HOSHIZAKI AMERICA, INC.

SERVICE BULLETIN

SB24-0008

Subject: KM stackable series drain hose change

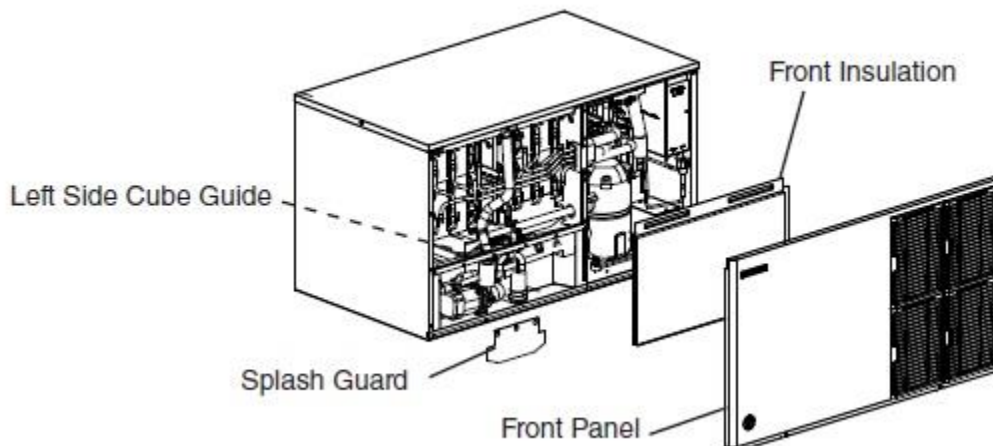
Drain hose, part number 324757-01 has been changed on all stackable series units.

This change started in September or October of 2023 depending on model number. See table below starting serial numbers break.

Model	New hose number	Starting serial number
KM-1301S_ KM-1601S_J(Z)/3	325867-02	N3 _ _ _ _K
KM-1900S _J(Z)/3	325867-01	N1 _ _ _ _K
KM-2200_KM-2600S_J(Z)/3	325867-01	N1 _ _ _ _J

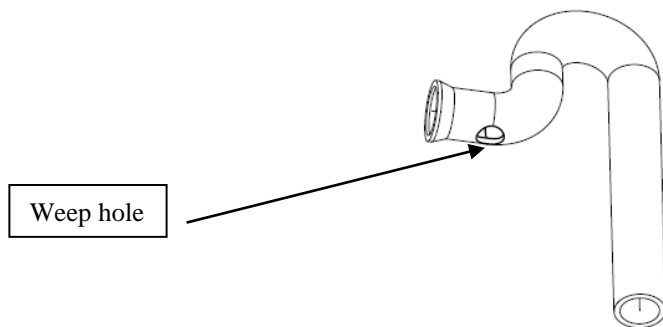
The drain hose is located under the left cube guide inside the reservoir.

The incorrect hose can be identified by the “weep” hole on the bottom of the hose. The correct hose has **NO** hole.

If you find your unit has the incorrect hose please order hose kit SP-5728 from your authorized Hoshizaki distributor.
